Ringwood Largescale Residential
Development, Shean Upper,
Blarney, Co. Cork

Further Information
Architectural Design Response - Phase 1

Cork City Council Further Information Request
Aug. 24

Fig 2A.3 Site Section 8-8

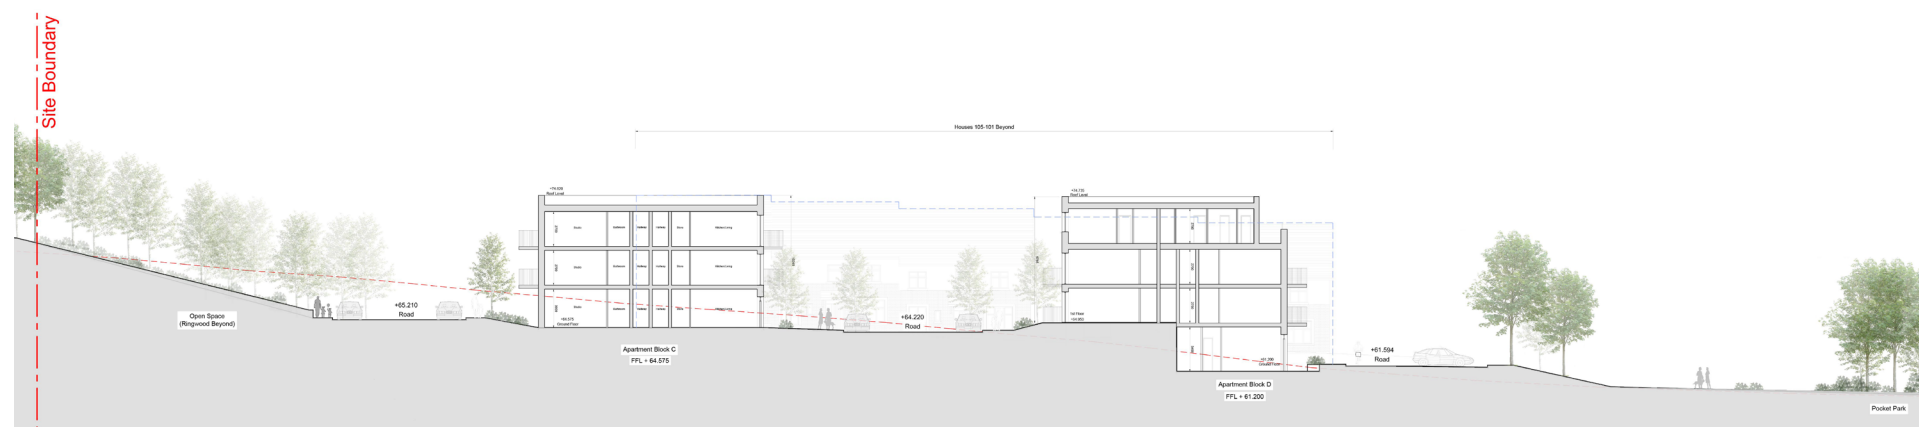
The provision of the additional apartment blocks east of the scheme is welcome in terms of achieving a higher density. The facades are well animated and the architectural language is consistent with the rest of the scheme. However 'Contiguous Elevation 5-5' suggests that the scale of the 4-storey block C may be excessive in the context of the neighbouring houses and the relatively elevated position within the site.

Please show consideration of these observations, along with sufficient drawn information to allow appraisal as to how these blocks will integrate within the topography and wider context of the scheme. Such drawn information should include a cross section through the blocks extending to the woods/pocket park either side, as well CGI views showing the blocks in relation to the surrounding streets and houses.

Regarding the concerns that the scale of the 4-storey Block D may be excessive in relation to the neighboring site, we have provided additional documentation to address this. Specifically, Site Section 8-8 and the updated Contiguous Elevation 5-5 illustrate Block D's relationship with the surrounding context, including the adjacent houses, the Ringwood, and the park. Site Section 8-8 demonstrates that, due to the stepped nature of the block and the site levels of the adjoining houses, Block D is broadly aligned with the ridge heights of houses 101-103, which similarly step up to accommodate the site levels and topography. We believe this demonstrates that Block D integrates well within the proposed context and that the transition in scale from one side of the street to the other is appropriate.

Additionally, we have provided a series of CGI (Artist Impression Views) to further illustrate this relationship. The use of different materials, including metal cladding on the top storey of Block D, assists in breaking down the massing of the block, thereby softening its perceived scale.

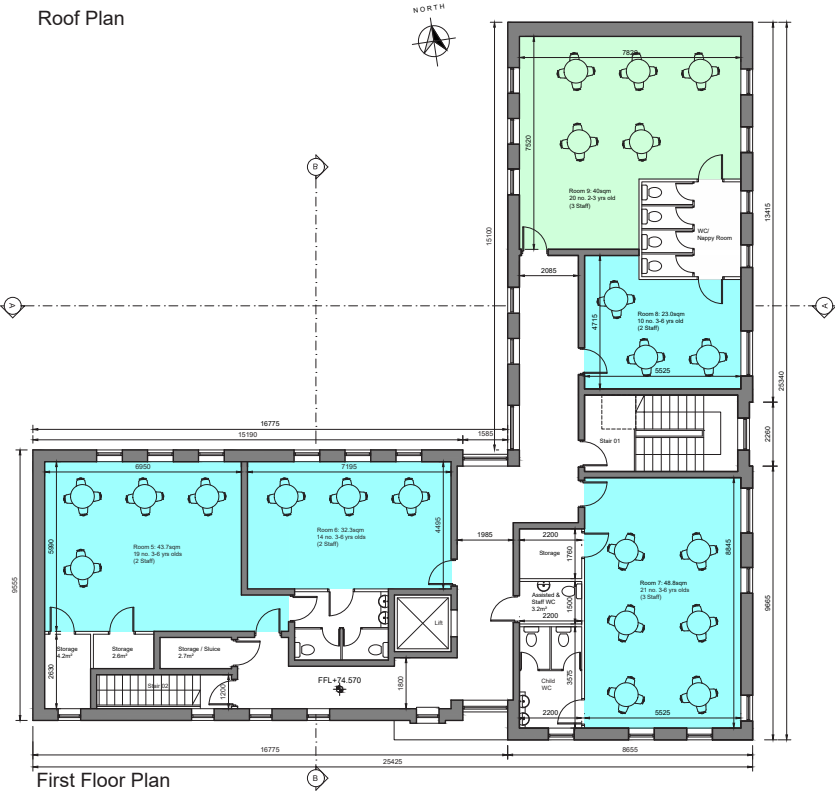
It is unclear, from the documentation submitted, if the proposed creche is to serve Phase 1 exclusively or the entirety of Phases 1 and 2. Noting the concerns raised in the Cork City Childcare submission, and the commercial reality of childcare provision, it is recommended that a single creche facility be provided, to serve both phases, as part of this application. It should have a minimum of 137 childcare places. Please address providing updated plans to show any alterations proposed.

A new, larger childcare facility has been proposed, with a gross floor area of 672 sqm plus an additional 79 sqm for external storage. This facility is designed to accommodate 137 children and 22 staff members, serving both Phases 1 and 2. To incorporate the larger building, we have omitted Houses G1 35 and H 36 and connected House G1 37 to House G1 38.
